TWIN CHIMNEYS

VILLAGE F

PLAT THREE

STORM & SANITARY SEWER MEASUREMENTS

STORM & SANITARY SEWER MEASUREMENTS

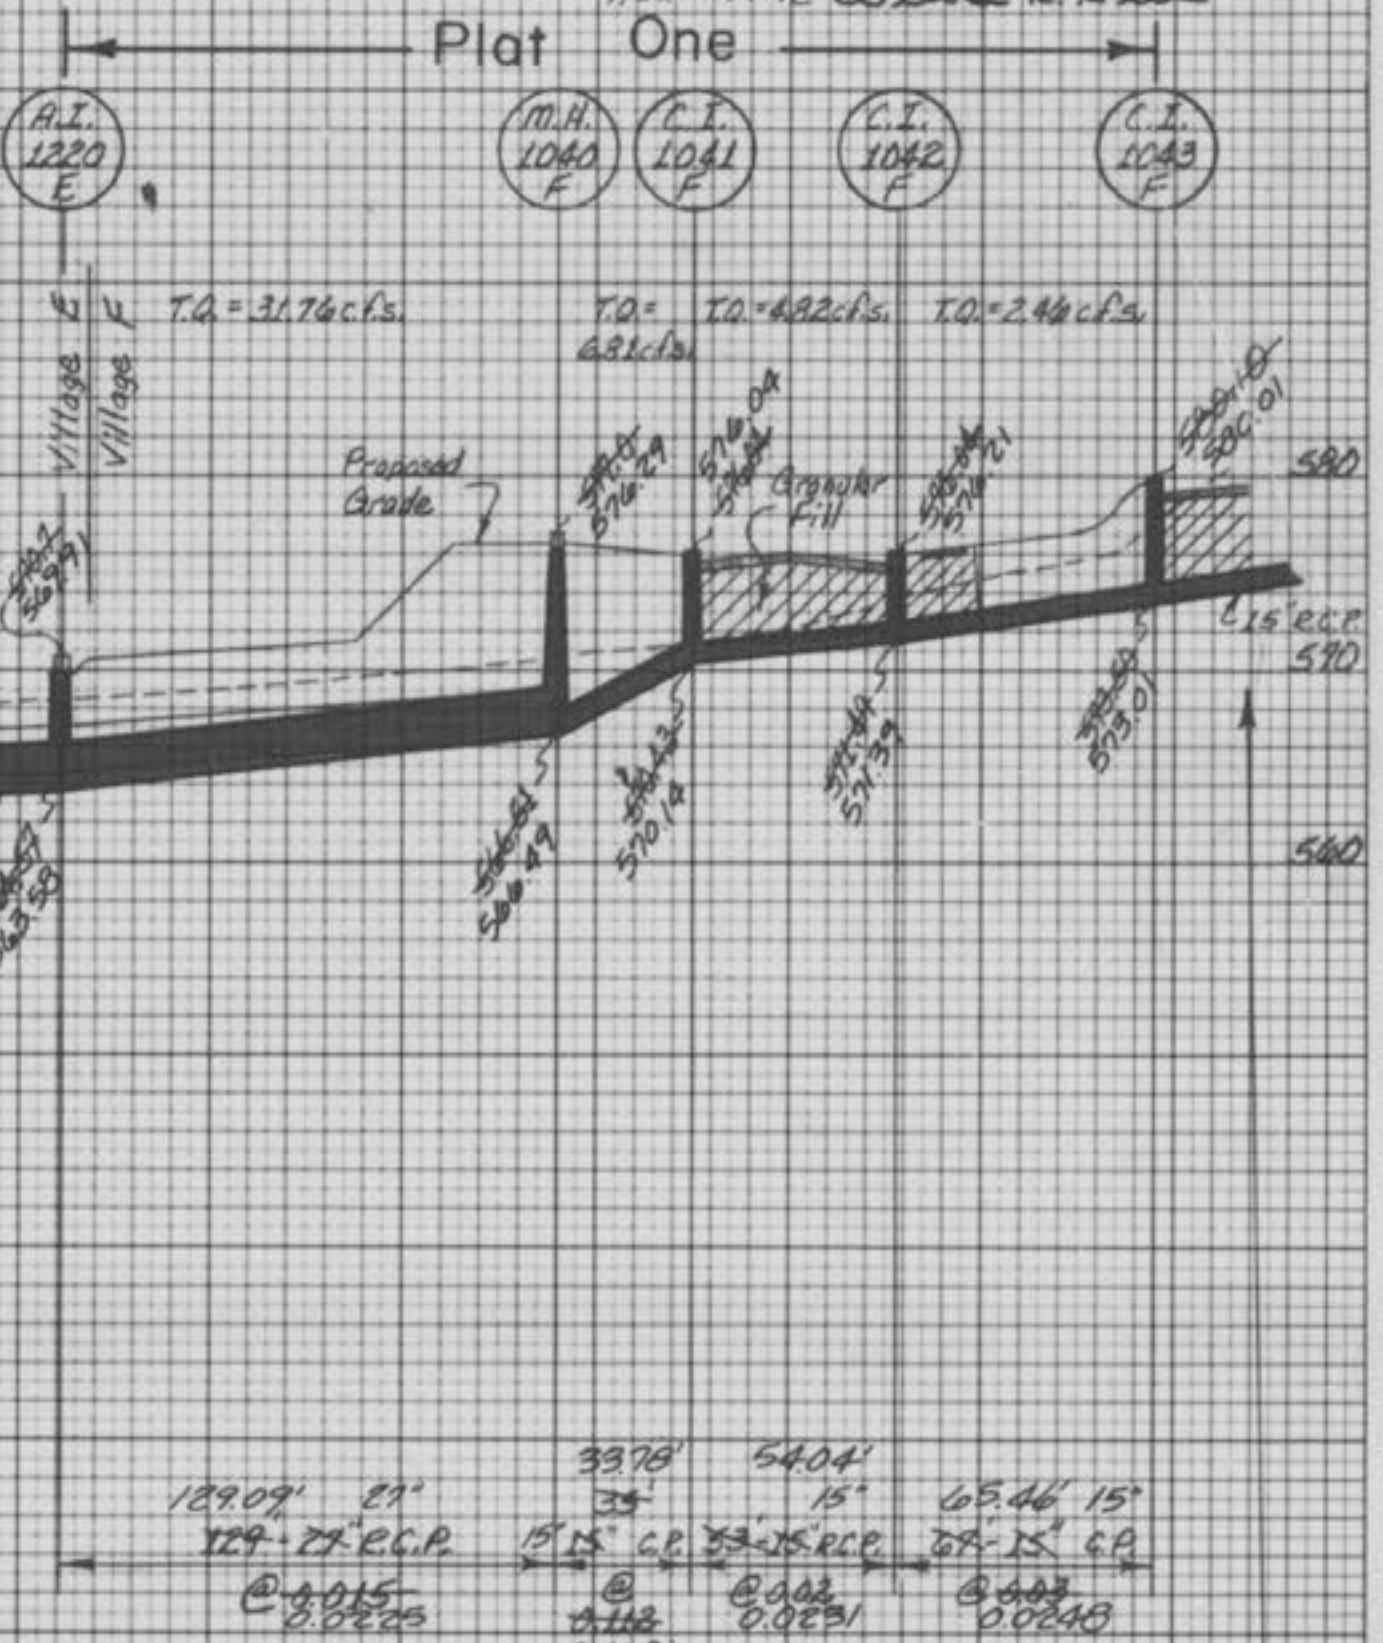
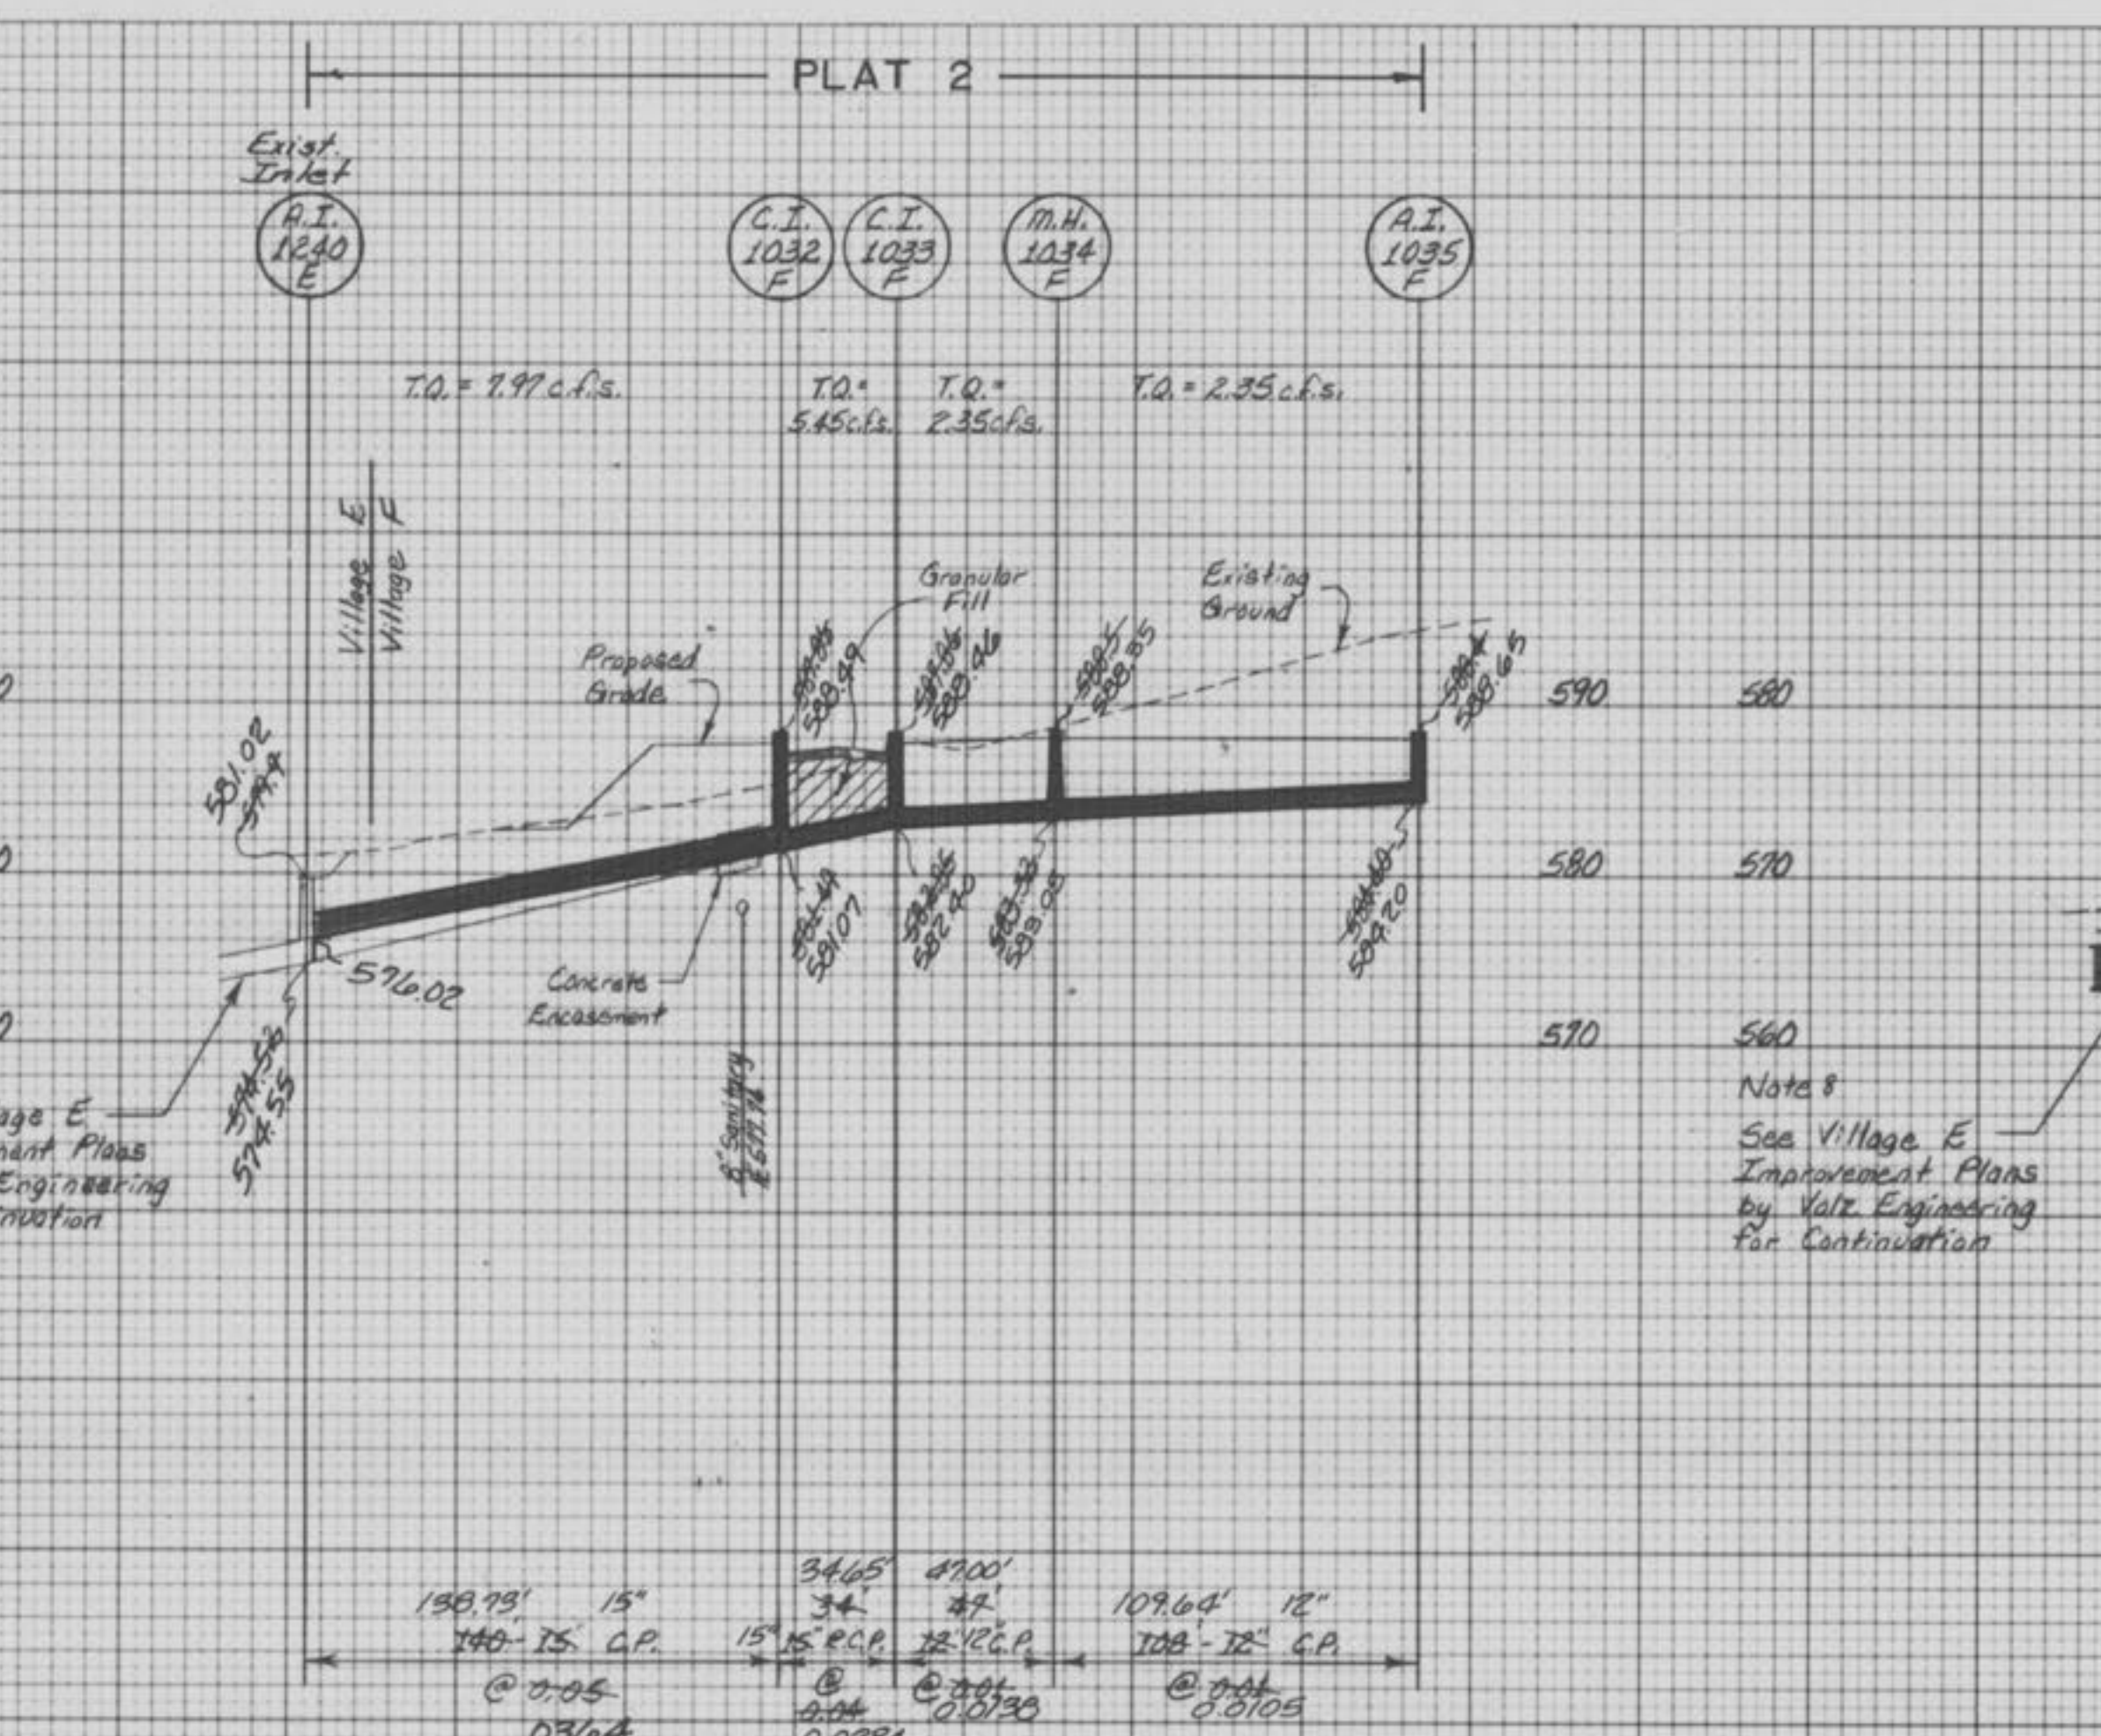
We have measured the existing sewer lengths, sizes, flowlines, depths of structures and the results of these measurements are shown on this plan by lining out the planned number and indicating the measured number adjacent to the planned number. All other numbers have not been measured or verified.
